BEFORE THE KENTUCKY PUBLIC SERVICE COMMISSION

ELECTRONIC APPLICATION OF THE)
 WESTERN MASON COUNTY WATER DISTRICT)
 FOR THE ISSUANCE OF A CERTIFICATE)
 OF PUBLIC CONVENIENCE AND NECESSITY)
 TO CONSTRUCT A WATER SYSTEM)
 IMPROVEMENTS PROJECT AND AN ORDER) Case No. 2024 - 00107
 AUTHORIZING THE ISSUANCE OF SECURITIES)
 PURSUANT TO THE PROVISIONS OF)
 KRS 278.020, KRS 278.300 AND 807 KAR 5:001)

RESPONSE TO COMMISSION STAFF’S FIRST REQUEST FOR INFORMATION

EXHIBIT 22

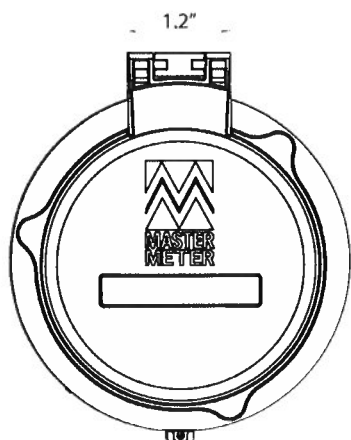
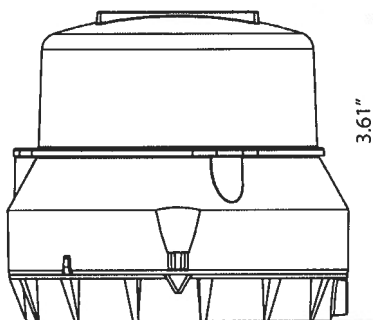
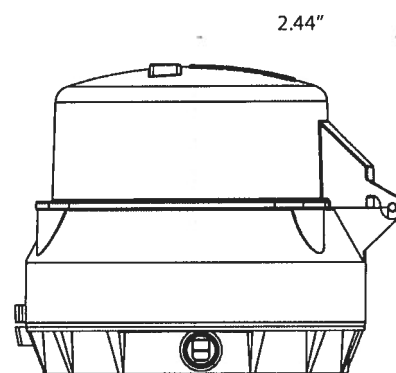
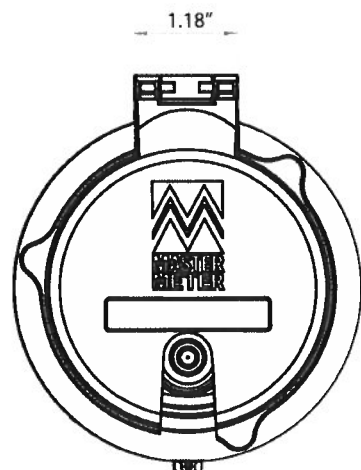
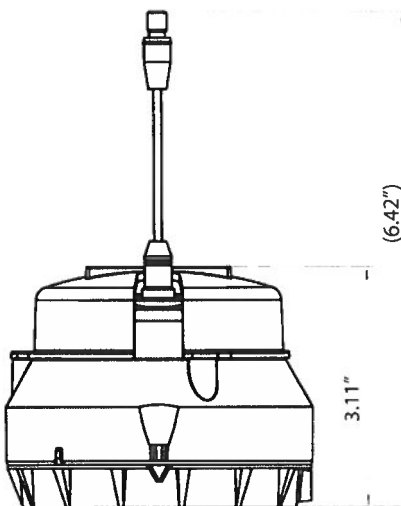
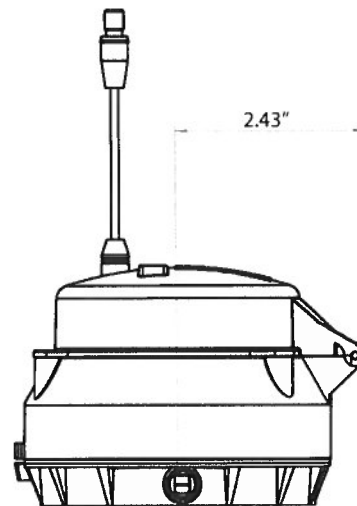
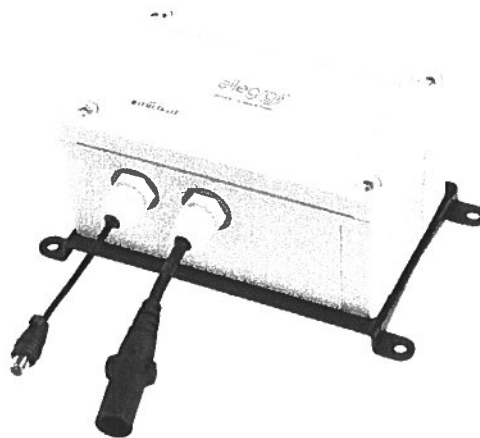
Request No. 22. State the expected service life for the proposed meters and provide any engineering reports or manufacturing data that support that expected service life.

Response No. 22. Master Meters have an expected battery life of 20 years (see attached **Exhibit 22**).

EXHIBIT 25

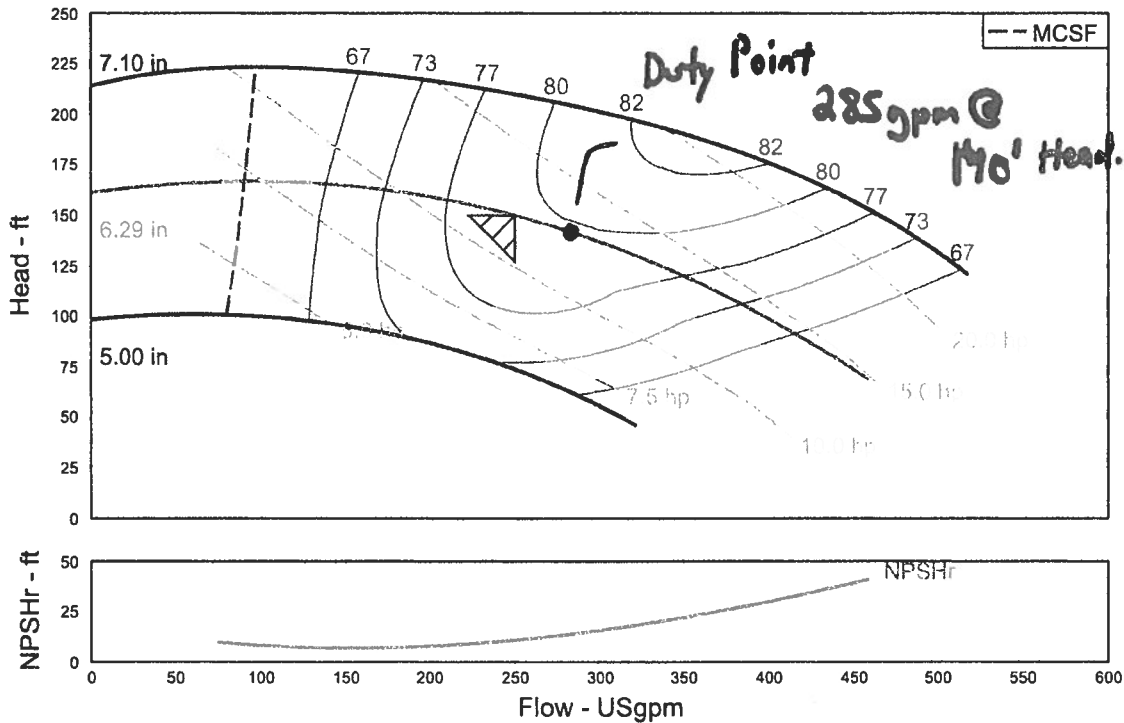
Request No. 25. Provide any hydraulic analysis models, maps, or other documents relating to the booster pump station and the water lines that are to be replaced.

Response No. 25. See attached **Exhibit 25** and the hydraulic analysis which is being filed with this Response.

Exhibit 2

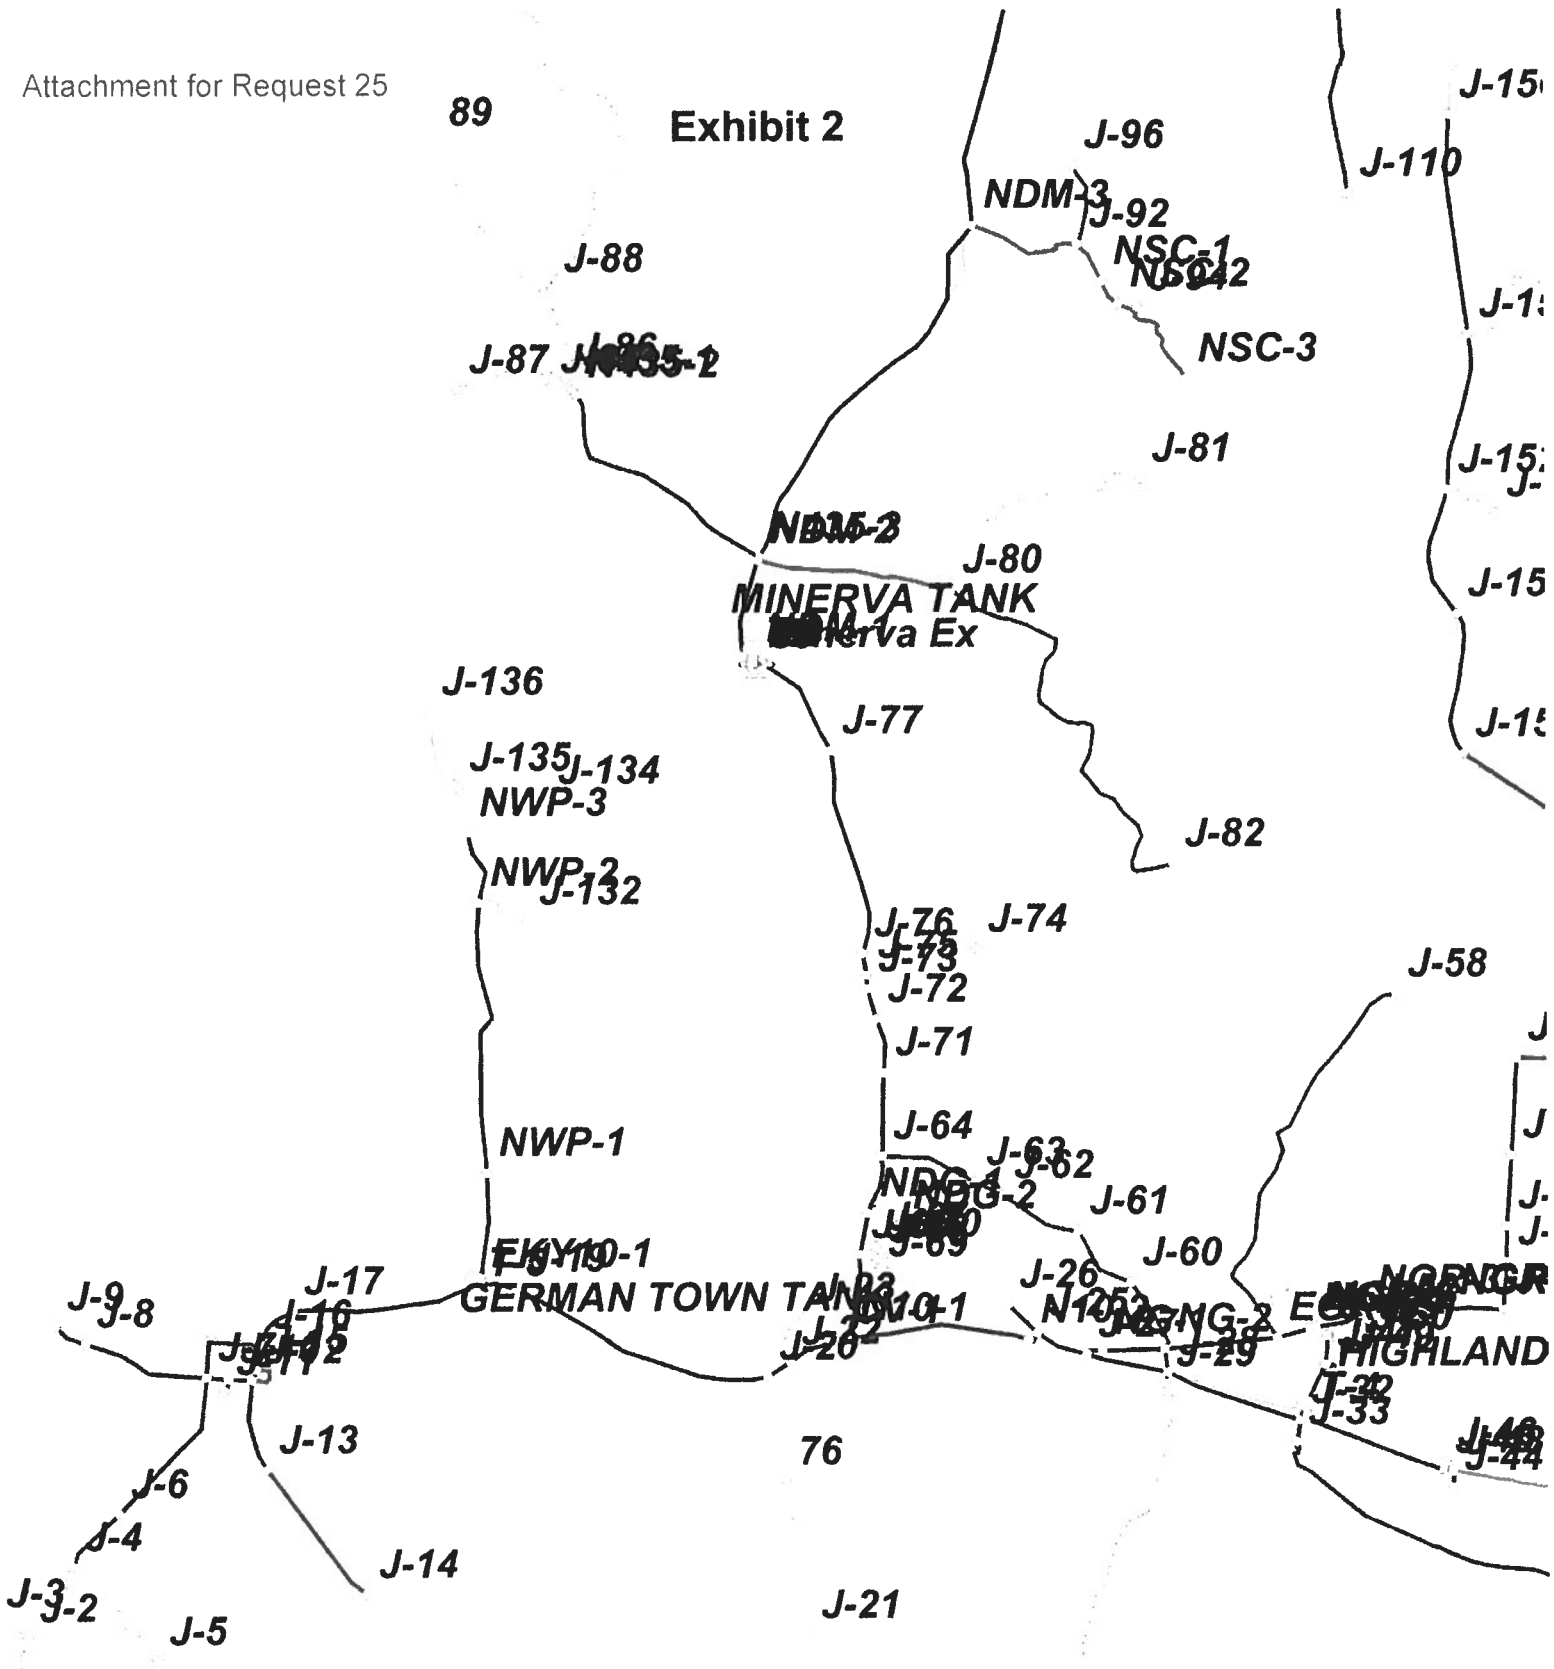
(b) State how Western Mason District determined the appropriate diameter of pipe for each section of the project.

Response No. 1(b). The diameter of pipe for each section of the project was recommended by the Engineer after performing a hydraulic analysis of the distribution system. A copy of the hydraulic analysis is being filed with this Response.
